**CONTRACT NO. T-711A, CAPITAL PROJECT 1651A  
EASTON-PHILLIPSBURG TOLL BRIDGE  
SALT STORAGE BUILDING**

**ADDENDUM NO. 1**

This **Addendum No. 1** gives additional information in connection with **Contract No. T-711A, Capital Project 1651A** and is hereby made a part of the Contract. This Addendum is to be signed by the Contractor and this **Page AD1-1** is to be attached to the bid proposal.

**FLOOR PLAN**

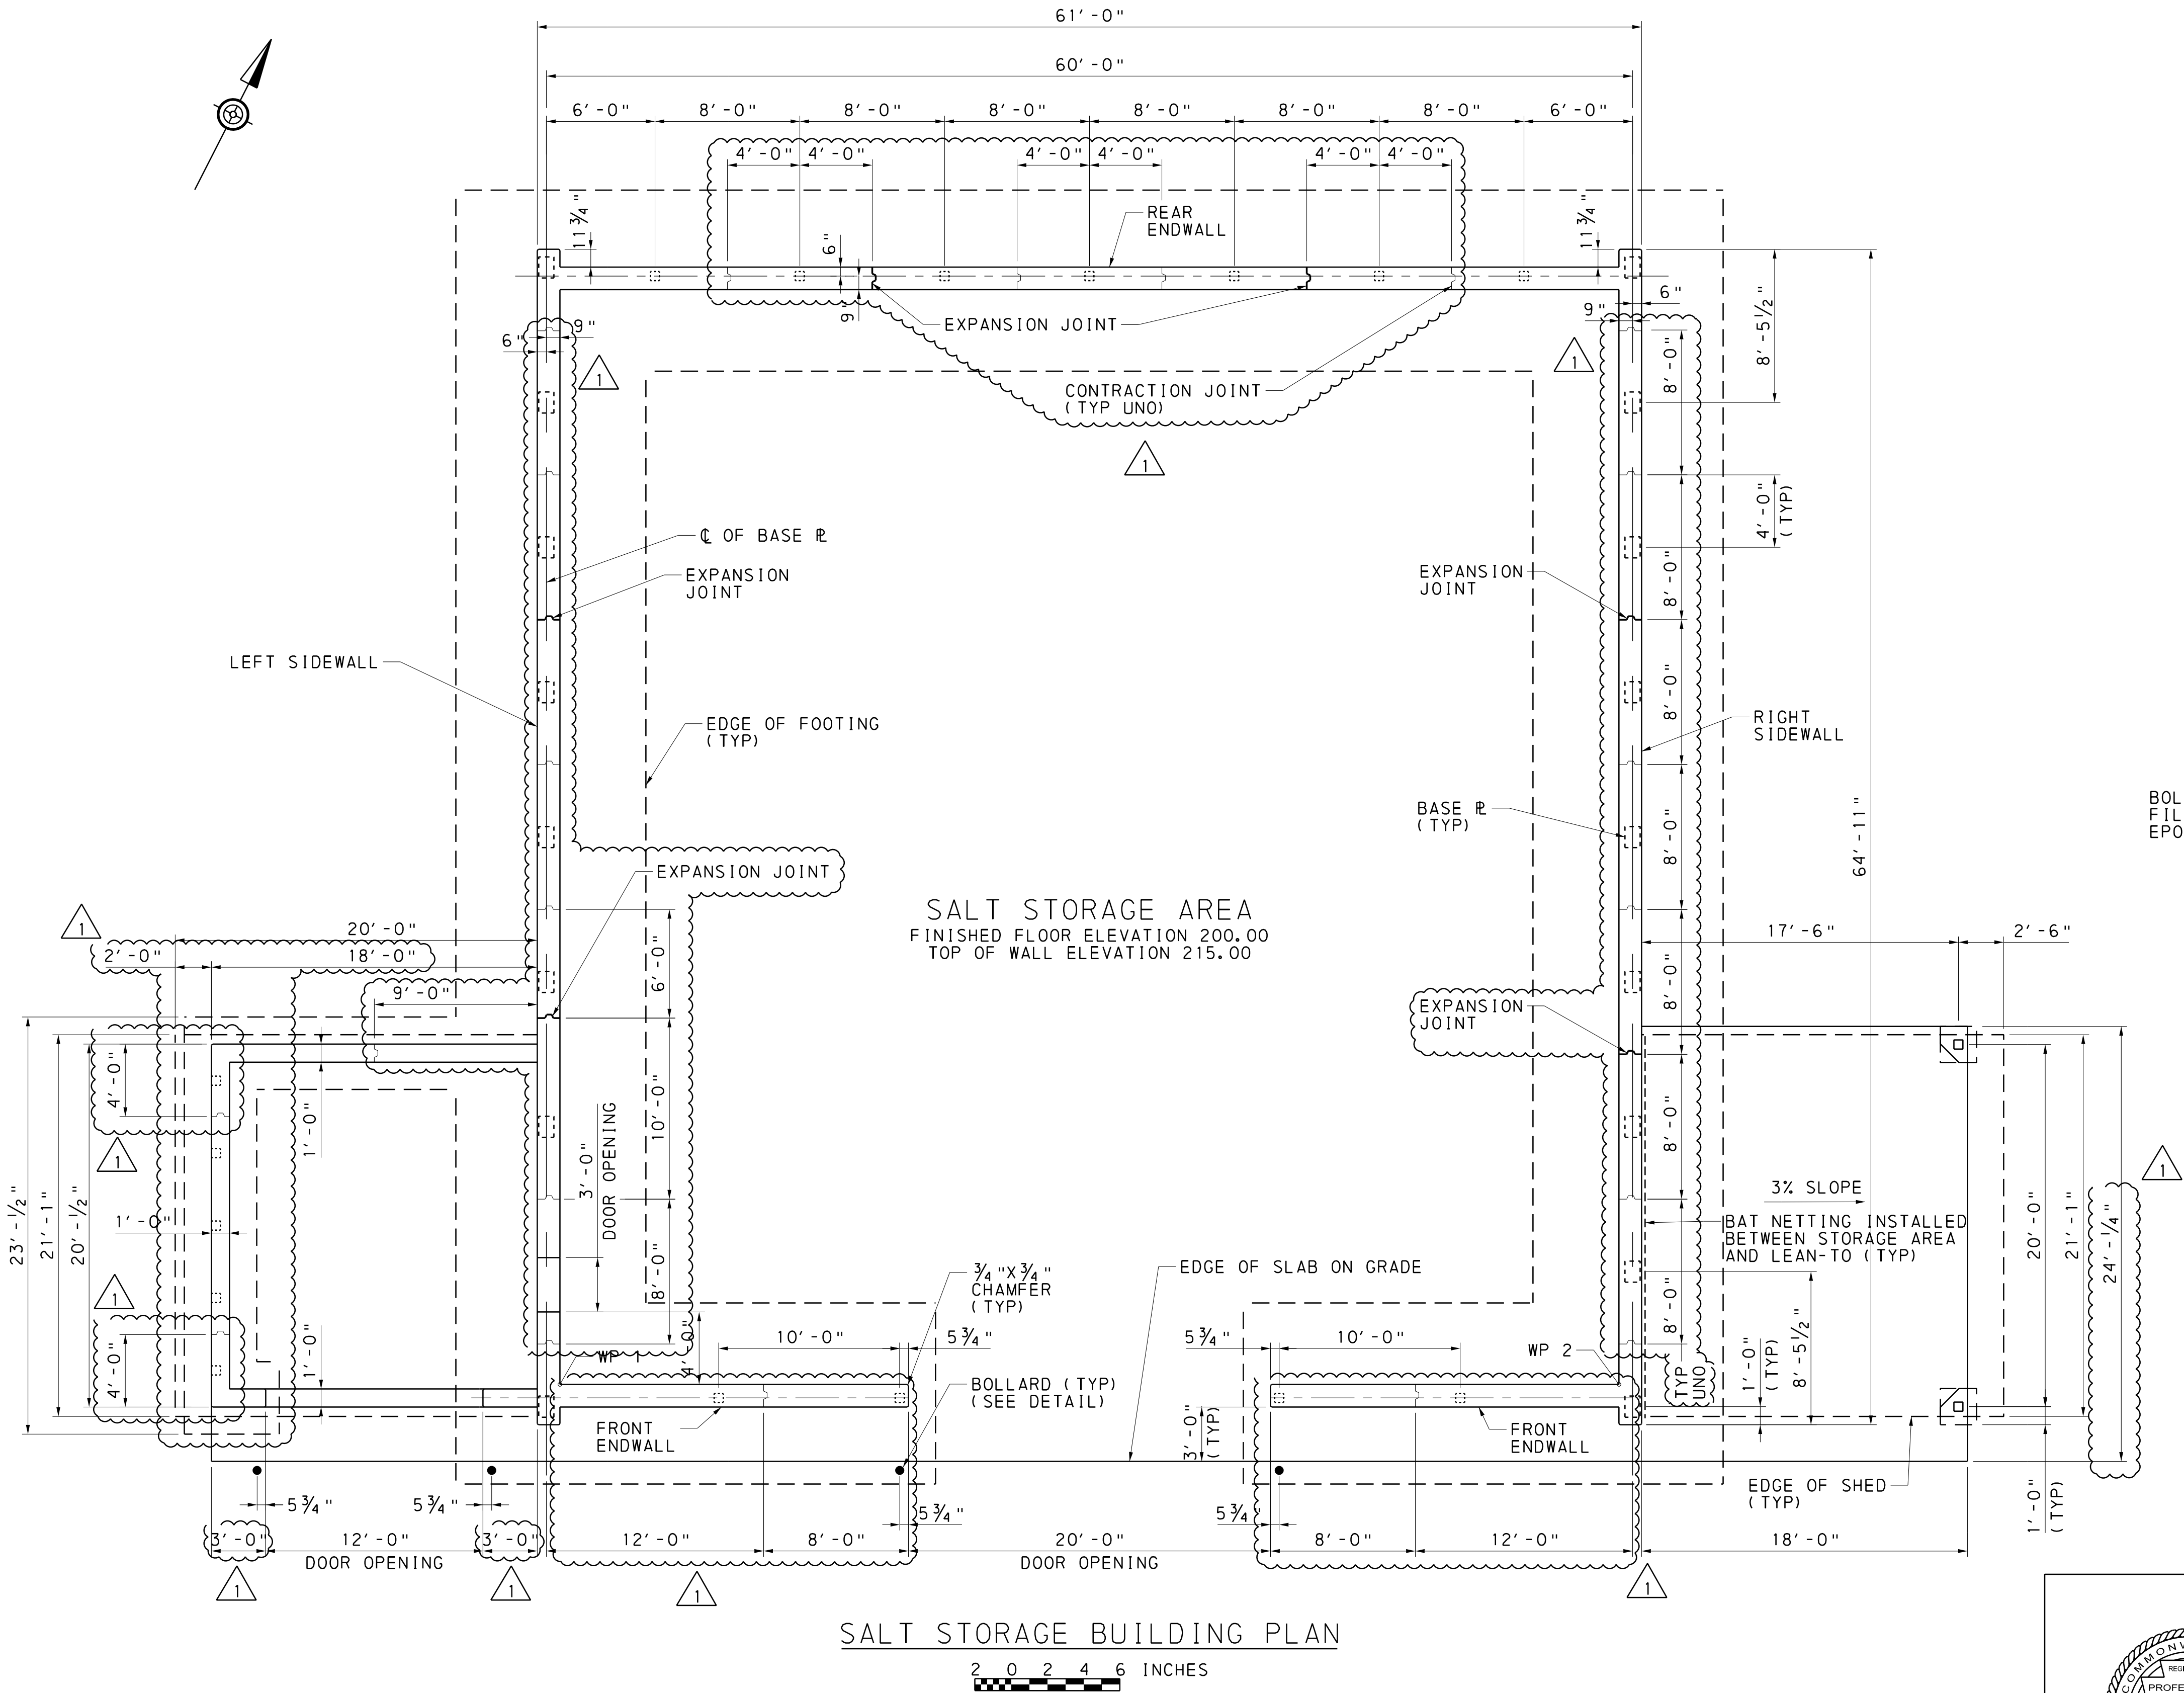
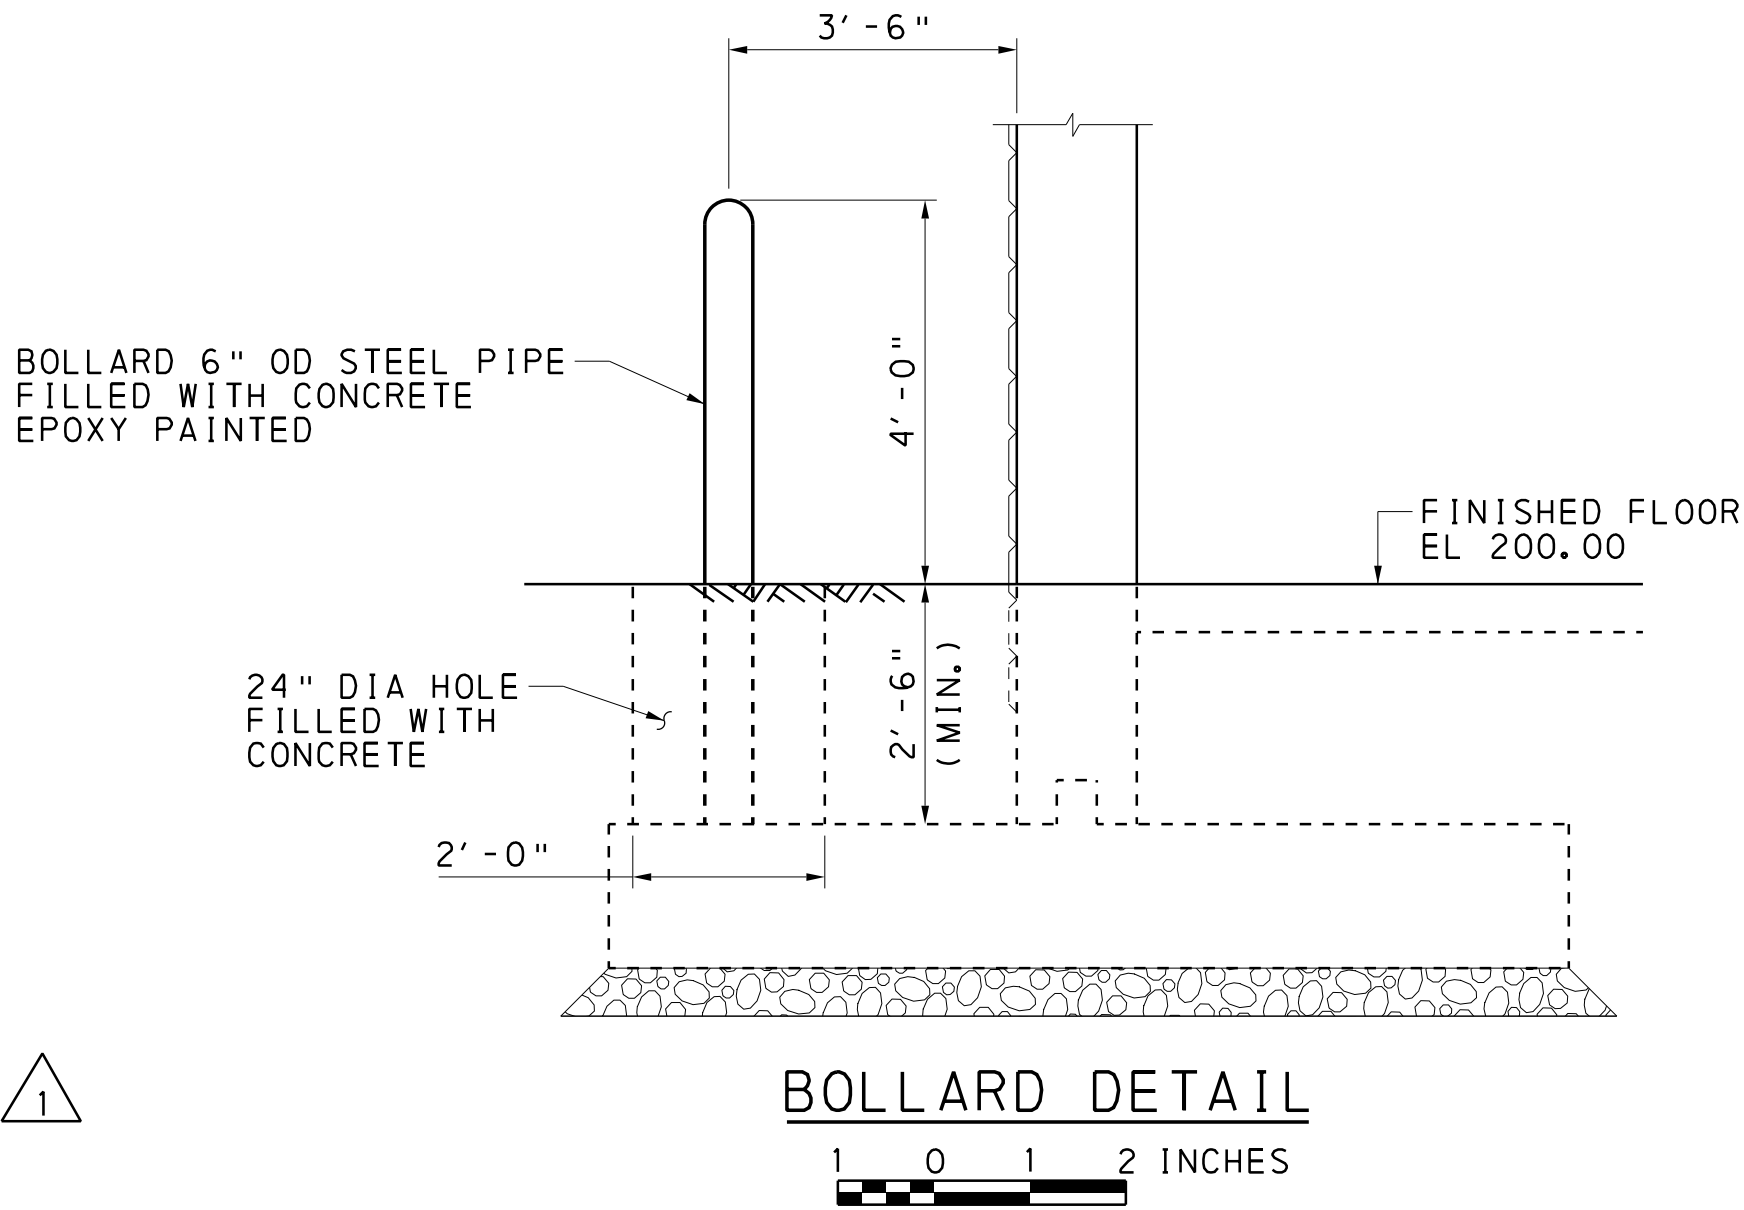
4. On Sheet 12 of 29, for SALT STORAGE BUILDING PLAN, Contraction Joint and Expansion Joint locations are revised.
5. On Sheet 12 of 29, for SALT STORAGE BUILDING PLAN, pallet storage area concrete wall layout is revised.

6. On Sheet 12 of 29, for SALT STORAGE BUILDING PLAN, proposed concrete slab at shed callout is revised.
7. On Sheet 12 of 29, for NOTE 1, replace all “TICKNESS” with “THICKNESS”.

FOUNDATION AND WALL  
PLAN

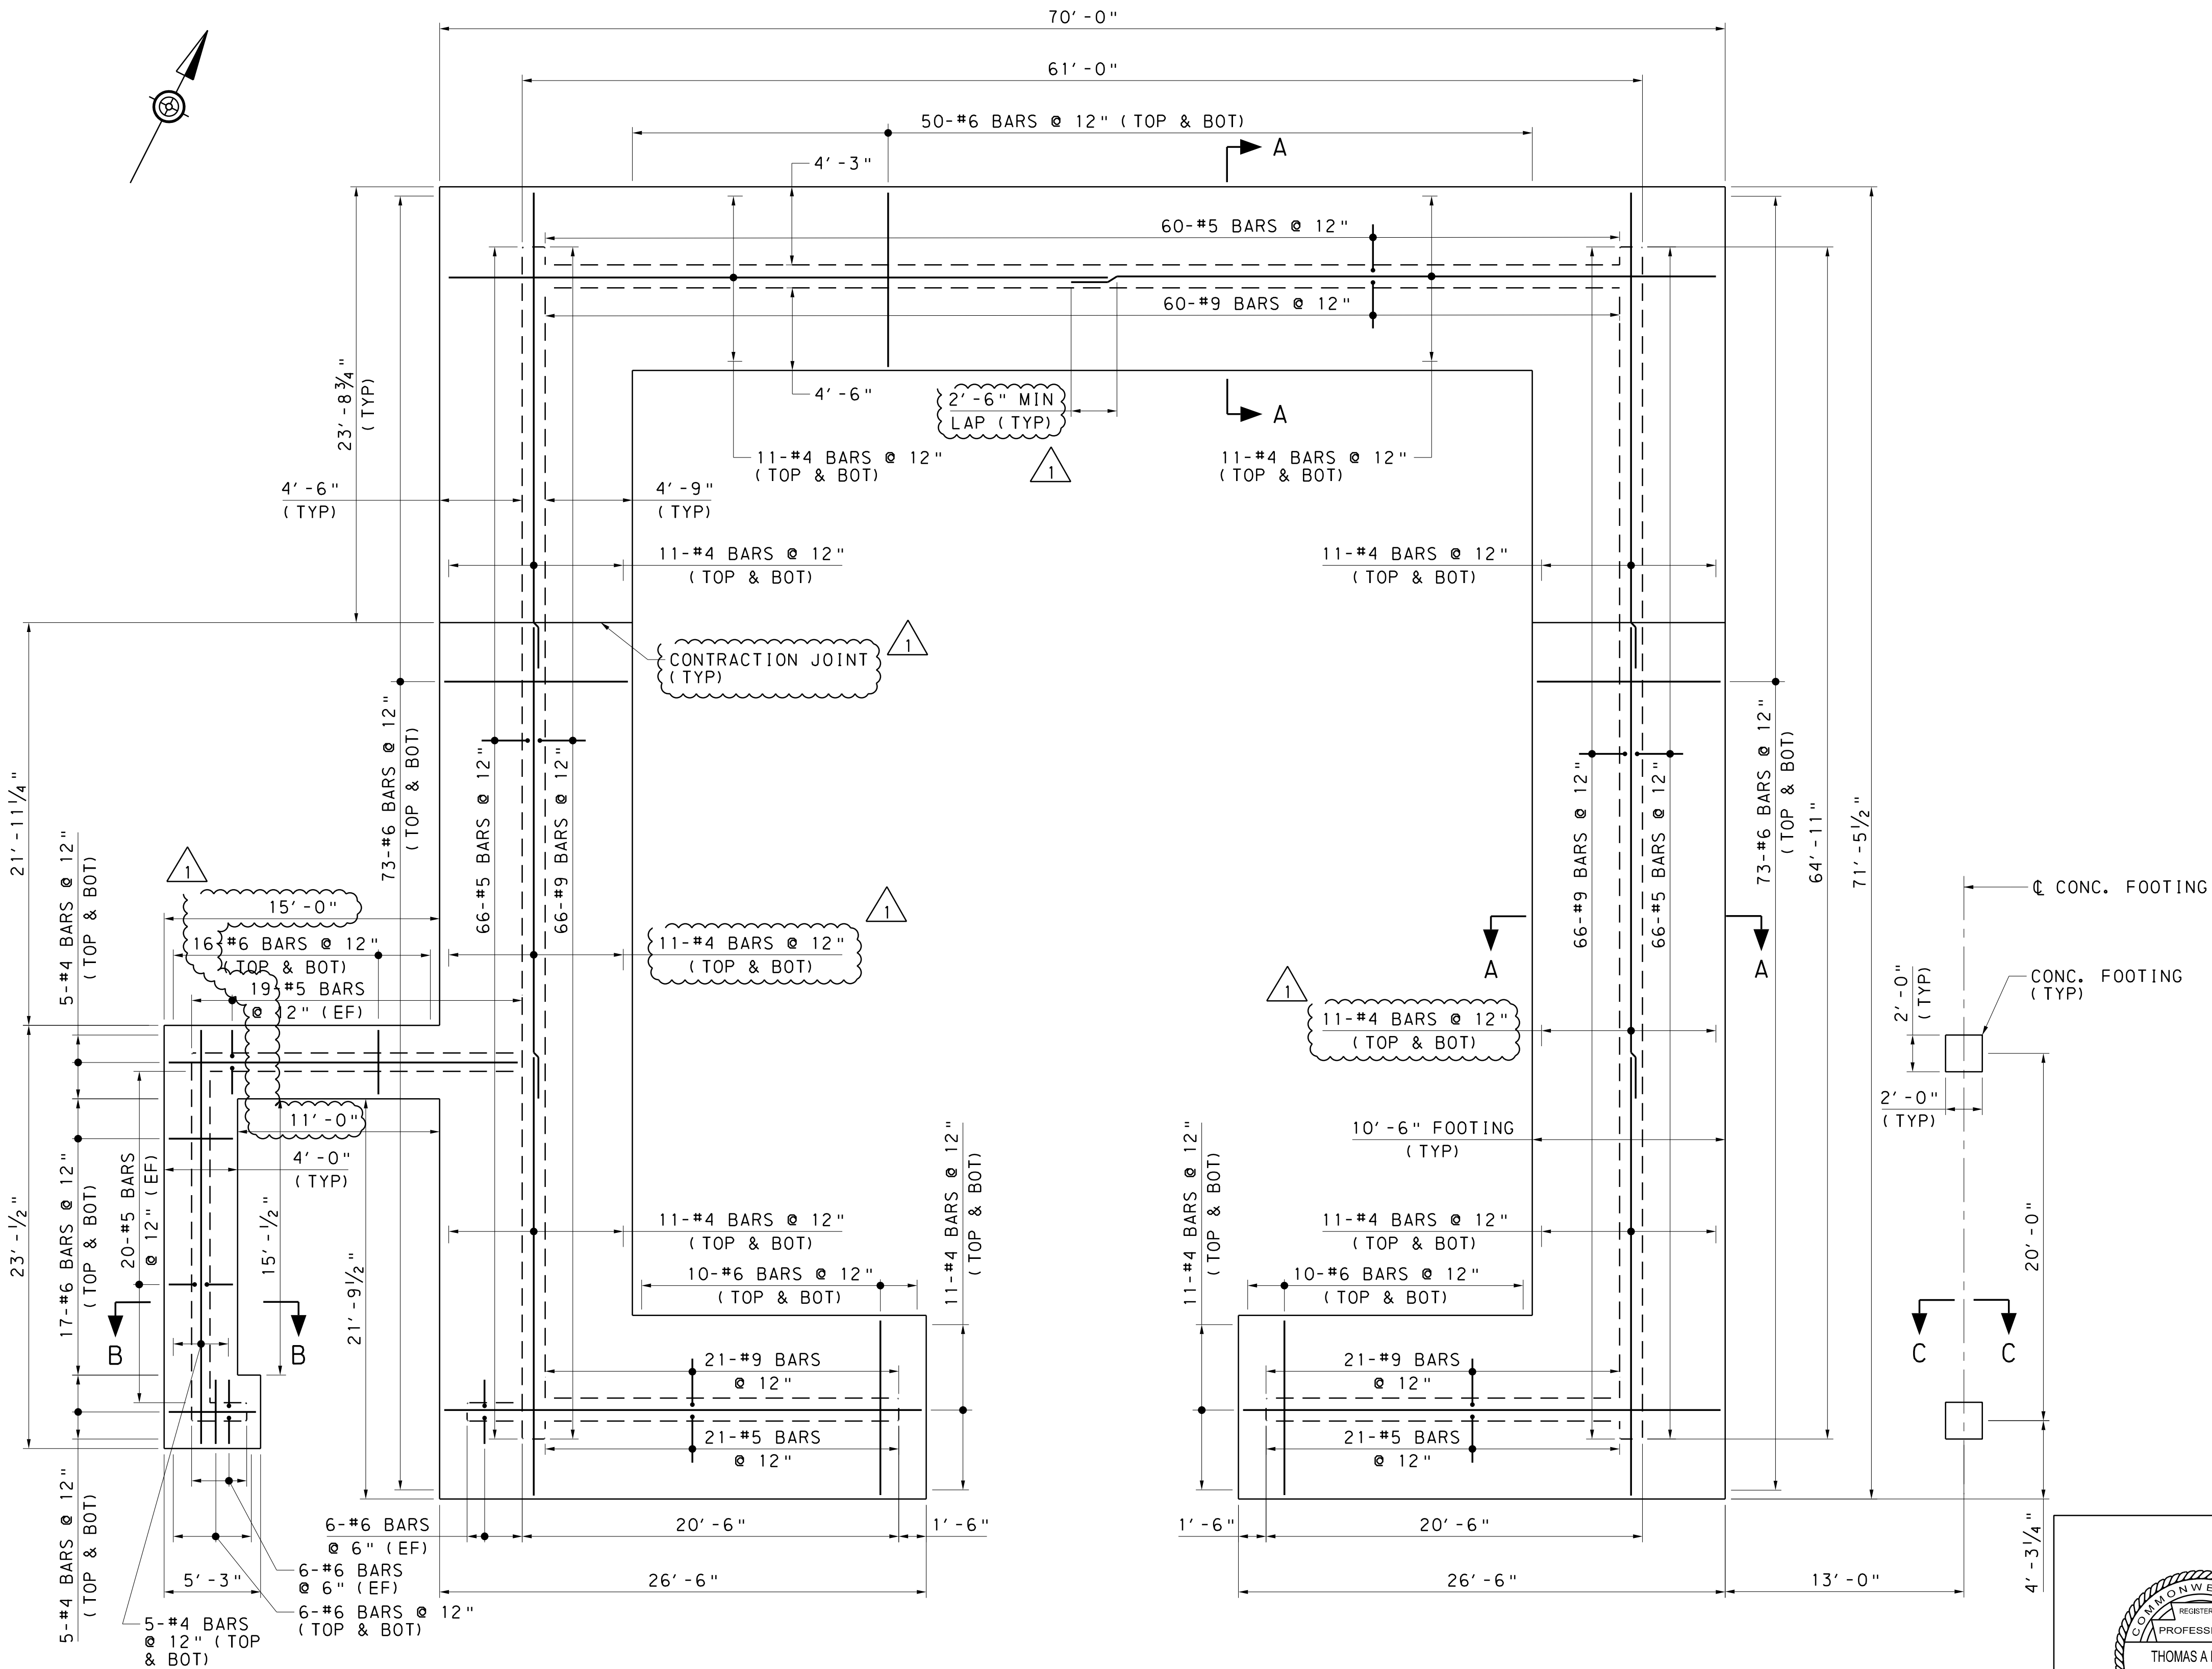
8. On Sheet 13 of 29, for FOOTING PLAN, replace “EXPANSION JOINT (TYP)” callout with “CONTRACTION JOINT (TYP)”.
9. On Sheet 13 of 29, for FOOTING PLAN, reinforcement callouts are revised.

10. On Sheet 13 of 29, for FOOTING PLAN, pallet storage area footing layout is revised.
11. On Sheet 14 of 29, for REINFORCEMENT DETAIL AT 12’-0” DOOR OPENING, reinforcement callouts are revised.

SECTION E-E

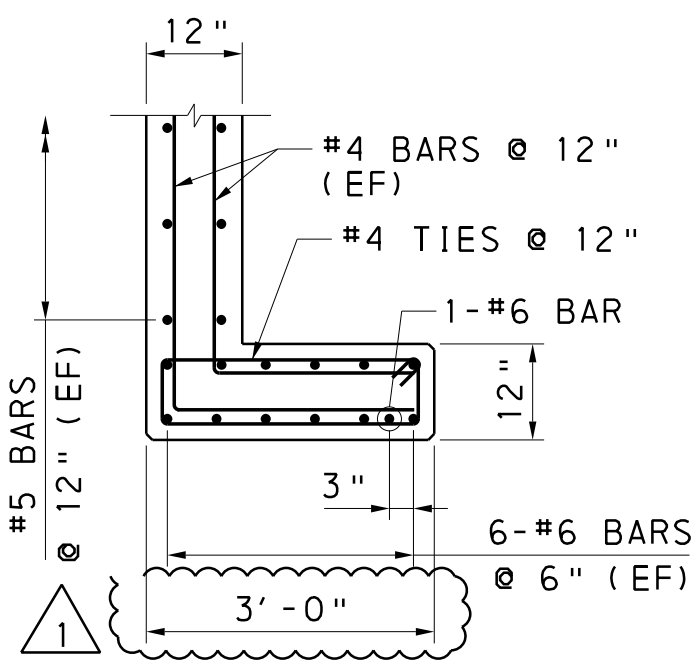
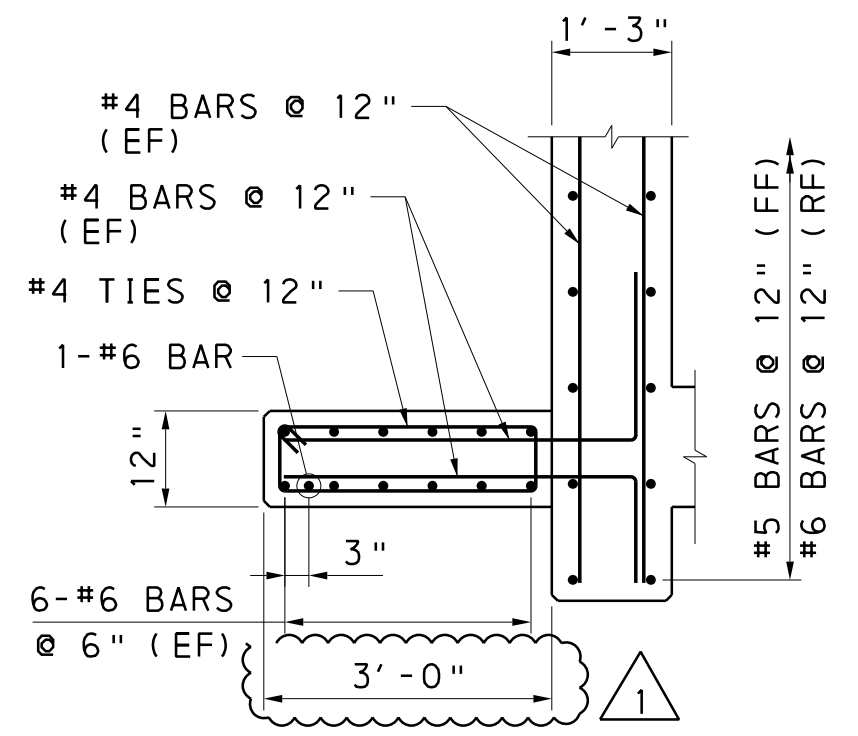
12. On Sheet 14 of 29, for SECTION E-E and SECTION F-F, concrete wall dimension callout is revised.
13. On Sheet 15 of 29, add the following detail:
